This Service Information bulletin supersedes SI B13 09 10 dated August 2010.
PERFORM THE PROCEDURE OUTLINED IN THIS SERVICE INFORMATION ON ALL AFFECTED VEHICLES THE NEXT TIME THEY ARE IN THE SHOP.

NEW Voluntary Emissions Recall Campaign 10E-A02: N54 High-Pressure Fuel Pump; Program Control Units

NEW E60, E61, E71, E82, E88, E90, E92, E93 with the N54 engine produced from 03/28/2006 to 02/26/2010

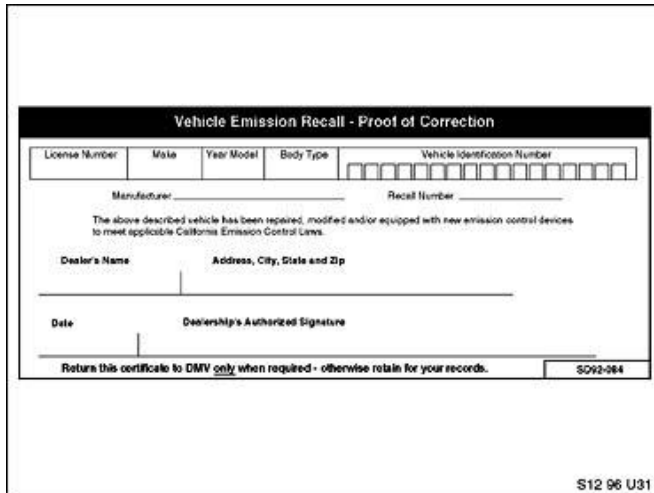
After the vehicle has been checked and corrected, obtain a label (SD 92-406) and with a ball point pen, print your dealer code (5 digits) on the Recall Completion Label (see illustration). An initial quantity of 200 labels will be sent to all BMW centers. Peel the label from its backing and affix it to the right (passenger) rear side of the hood in the engine compartment, close to windshield.
